Department of Energy
Washington, D.C. 20545
Docket No. 50-537
HQ:S:82:169

CONTAINMENT VESSEL/CODE CASE(S) ANALYSIS WORKING MEETING - SUMMARY

Containment Vessel/Code Case(s)
Analysis Working Meeting - Summary

A working meeting was held on December 8, 1982 to resolve NRC concerns to the Containment Vessel/ASME Code Case(s) Analysis. The presentations and subsequent discussions responded to NRC concerns in the following areas:

INSERT A

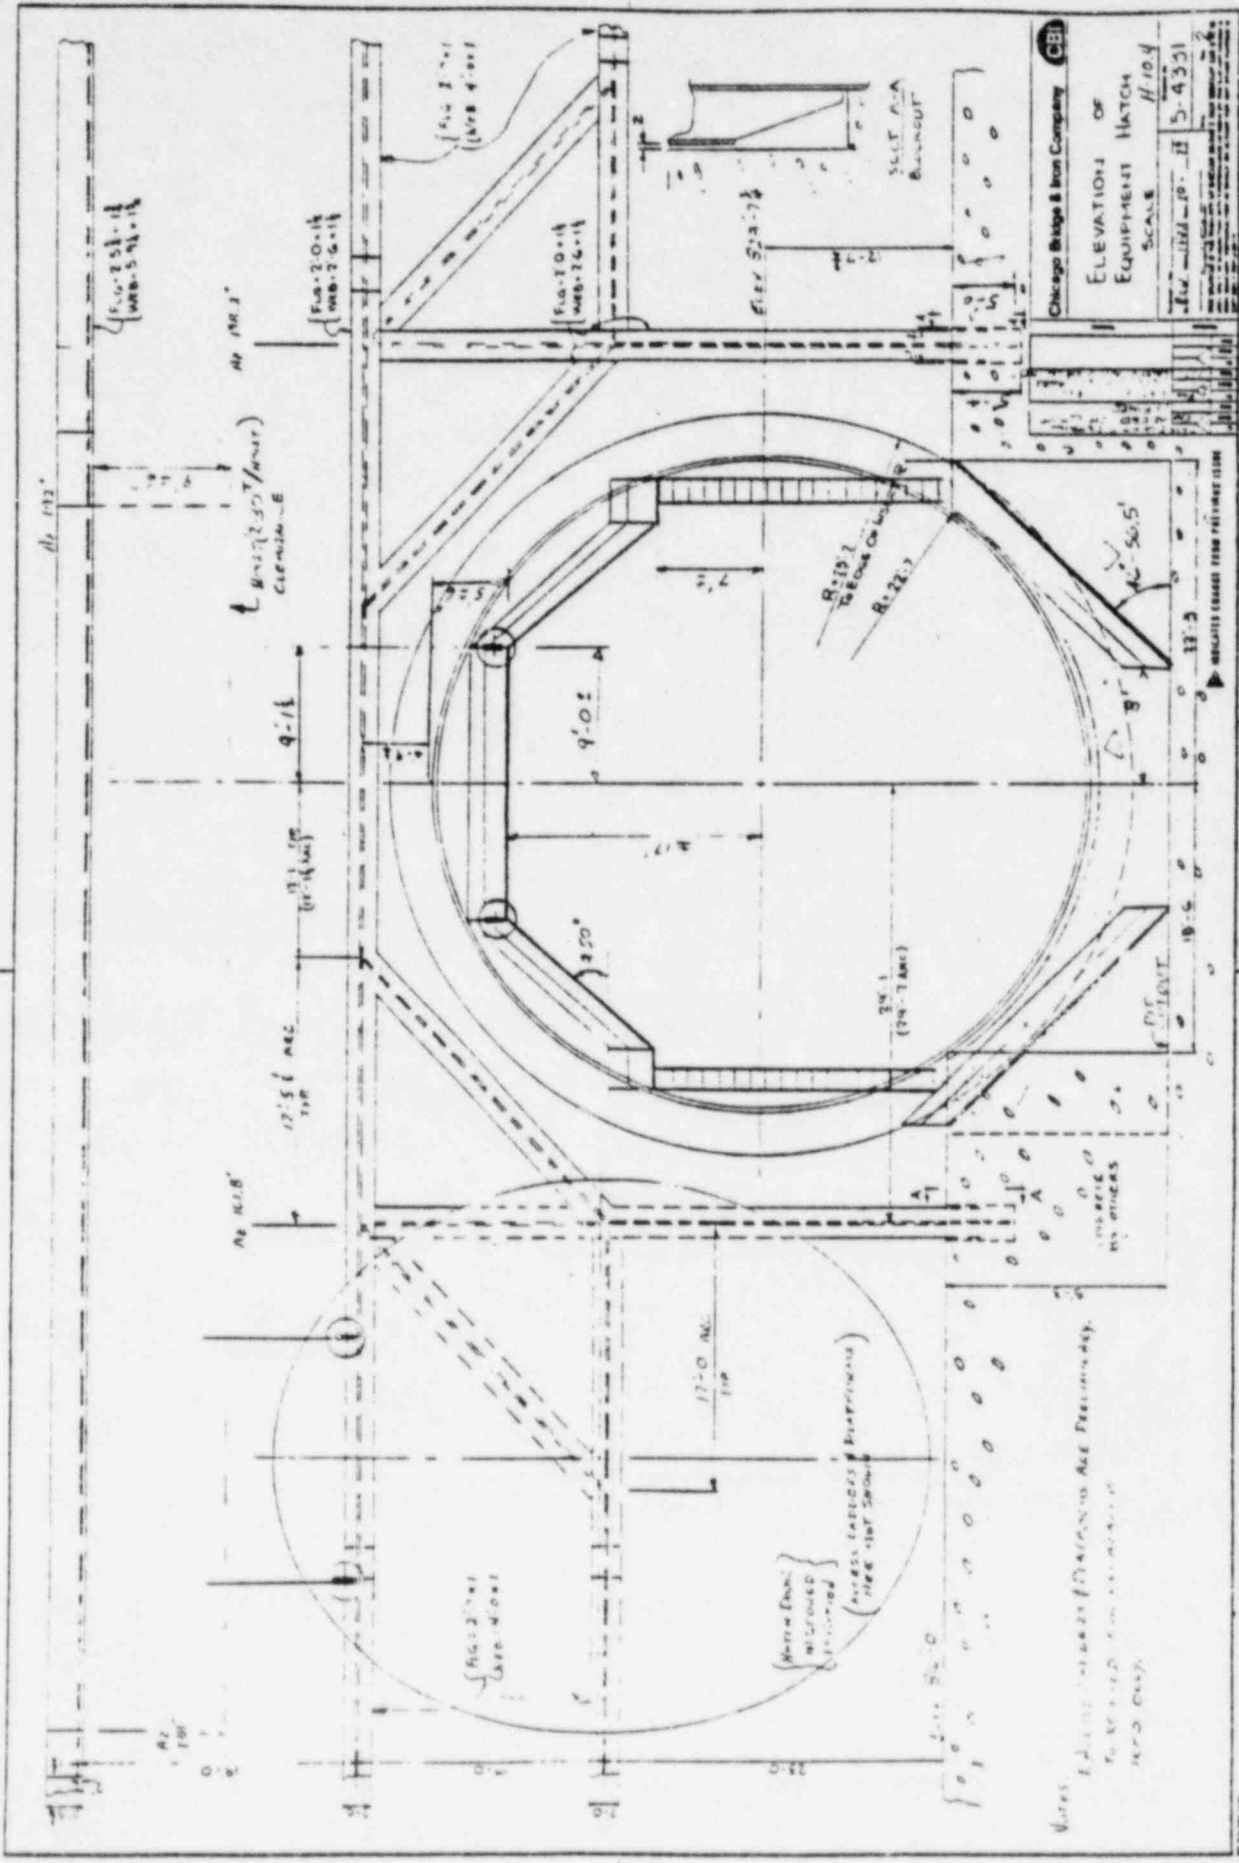
New question: Evaluate the stress in the shell above the equipment hatch and the horizontal stiffener.

As a further justification for assumption that an opening the size of the equipment hatch, if properly reinforced, will not deteriorate the buckling capability of the vessel, we refer to a paper entitled "Experimental Study of the Buckling of Cylindrical Shells With Reinforced Openings". This paper authored by C. D. Miller was presented at the Second Joint ASME/ANS Nuclear Engineering Conference, Portland, Oregon, July 25-28, 1982. Figure 2 of this paper presents the results for Model #1 which had an opening with r/\sqrt{RT} of 6.36 which is identical to that of the hatch opening. This figure indicates that the buckling capability of the cylindrical shell under axial compression was not reduced by the presence of the opening, when the opening was reinforced by area replacement rules. A number of other investigators have demonstrated by tests that for cylinders under axial compression, a reinforced opening could be of fairly large size without deteriorating the buckling capability of the unpenetrated shell. This is particularly true of fabricated shells. Due to fabricated cylinders sensitivity to imperfections, under axial compression, the knockdown factors from classical buckling values are significant. These knockdown factors would allow for considerable local disturbances and stress concentrations without causing buckling.

A number of other investigators have demonstrated by tests that for cylinders under axial compression, a reinforced opening could be of fairly large size without deteriorating the critical buckling capability of the shell. This is particularly true for fabricated shells under axial compression where the imperfection knockdown factors from classical buckling values are significant. Effects of the penetration are found to be more significant than imperfections and test results including penetrations are within the scatter of test results of unpenetrated shells. The CRBRP containment shell has been evaluated against ASME Code Case N-284 which uses knockdown factors established from lower bound test data of fabricated vessels without penetrations. Test results also indicate these knockdown factors will provide lower bound values to test data obtained from vessels with penetrations.

SAD IV ANALYSIS OF AIRLOCK

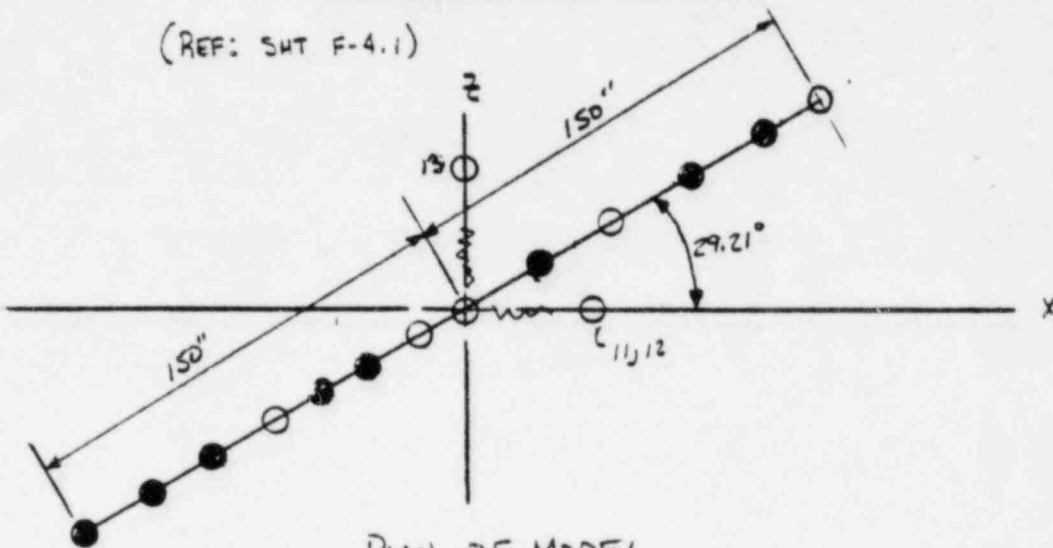
- a) Finding (1.C.1.A) - In evaluating the equipment and personnel airlock for seismic loads, an assumption was made that it penetrates containment in a radial direction. To develop the dynamic model for the airlock, only two degrees of freedom were allowed; radial and rotation about a horizontal axis. In addition, with the maximum live load in the extreme end of the airlock, its fundamental frequency is below the peak of the design response spectrum for that location. To adequately evaluate the airlock the following needs to be done.

In response to the stated concerns of the reviewers, the dynamic analysis in Section F was reexamined and we offer the following explanation to the reviewers in response to their concern.

1. The center of gravity of the airlock would move toward the center of the airlock. This would reduce the moment arm distance. With a reduced moment arm, the circumferential moment and the longitudinal moment would be reduced significantly whether or not the live load itself was reduced.
2. The frequency of the airlock would increase but would remain approximately within a 10% range. A higher frequency would result in a slightly higher first mode spectral acceleration. However, the final airlock accelerations would only change an insignificant amount. This insignificant change in acceleration would not be greater than the significant reduction which would occur from Item #1.
3. The force or moment on the shell will decrease.
